REGIONAL REVIEW NOTIFICATION

Name of Proposal: Fun World Palace and Resort

Review Type: Development of Regional Impact

Preliminary Report:	December 23, 2005	DEVELOPMENT OF REGIONAL IMPACT REVIEW REPORT	Project:	Fun World Palace & Resort #938
Final Report Due:	January 22, 2006		Comments Due By:	January 6, 2006

FUN WORLD PALACE & RESORT

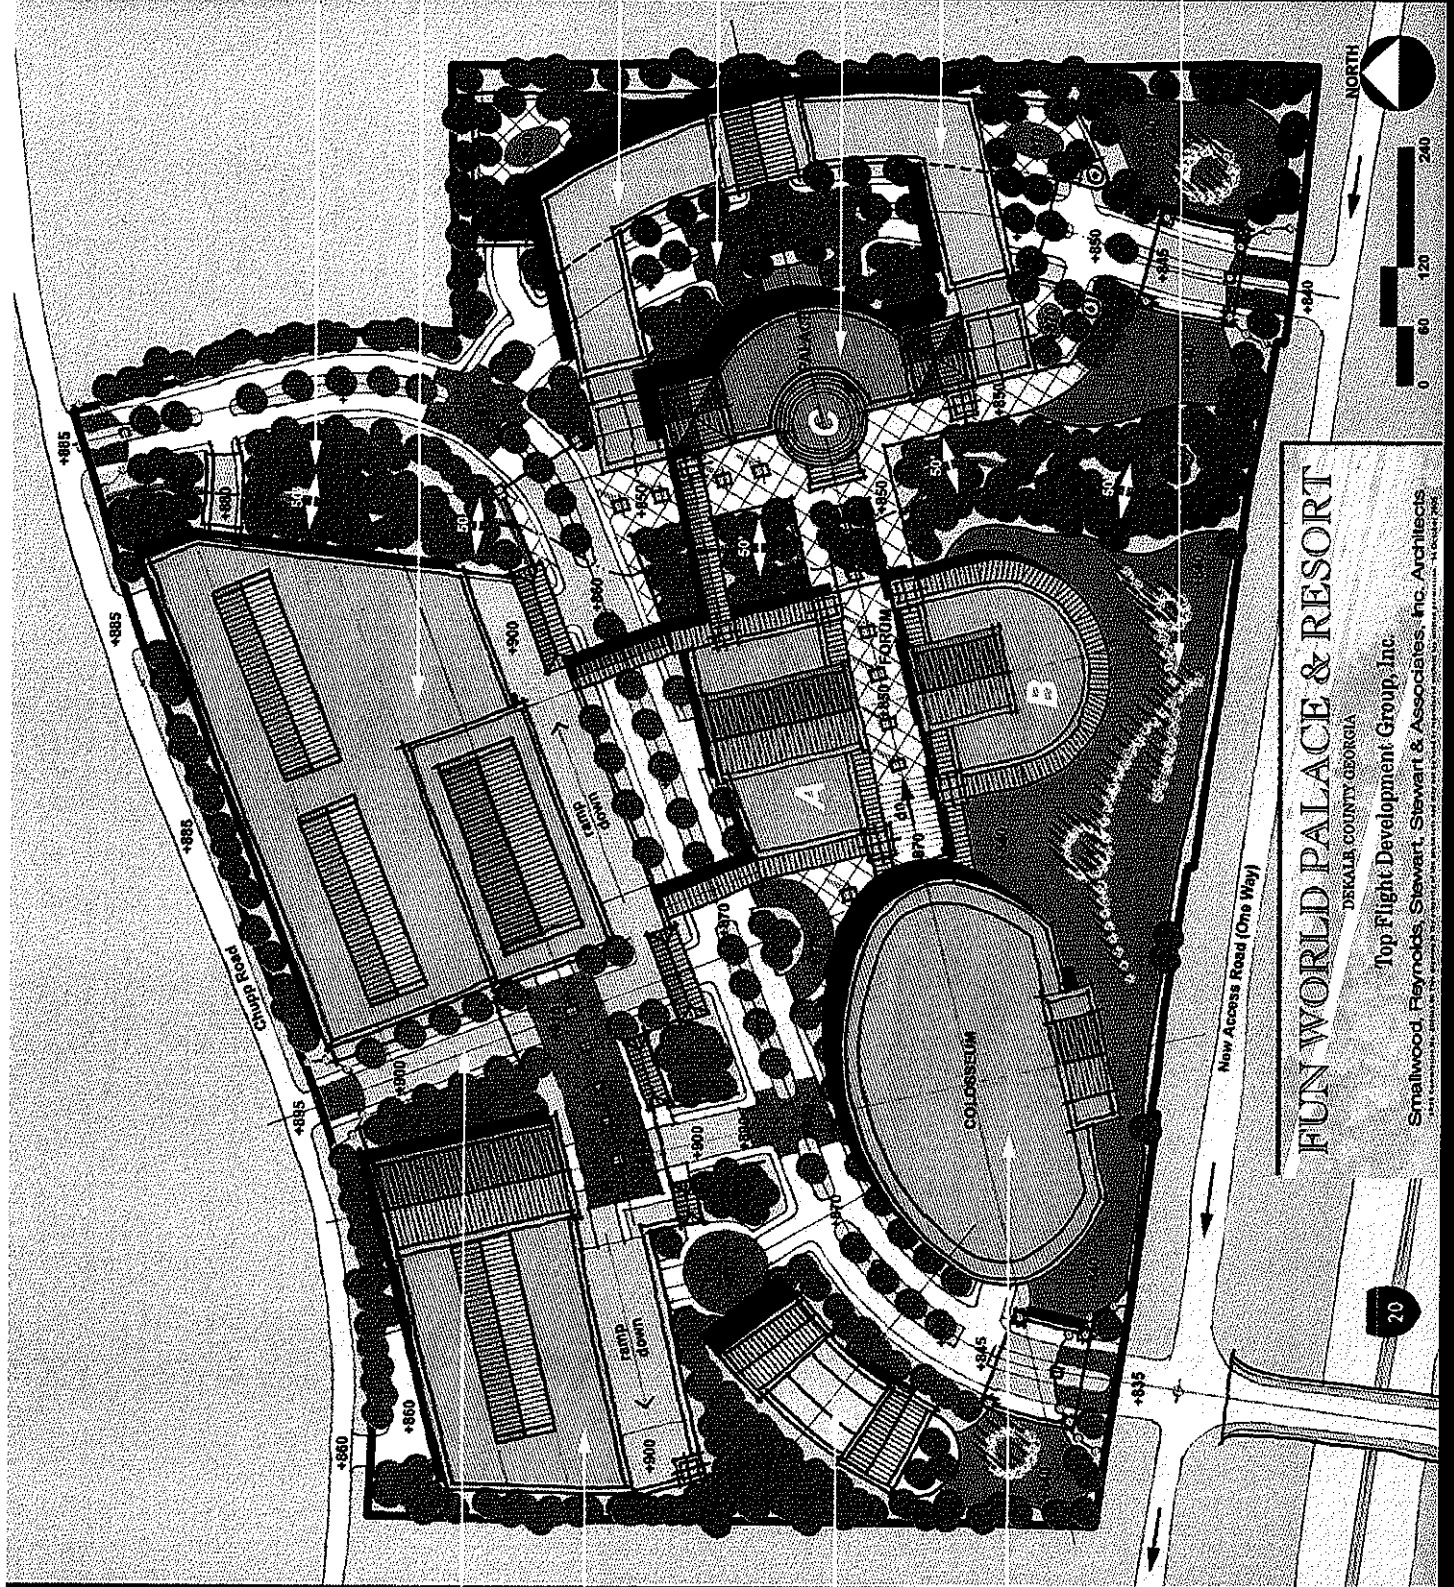
The staff finding is contingent upon proper review by the Georgia Department of Transportation because of the unusual design of the site entrances along the frontage road and the need for proper coordination.

The proposed development places great attention on the pedestrian. The site plan depicts a main boulevard and enclosed parking garages that encourage individuals to park and walk throughout the development. All aspects of the development are easily accessible for the pedestrian with clearly marked paving patterns and covered walkway
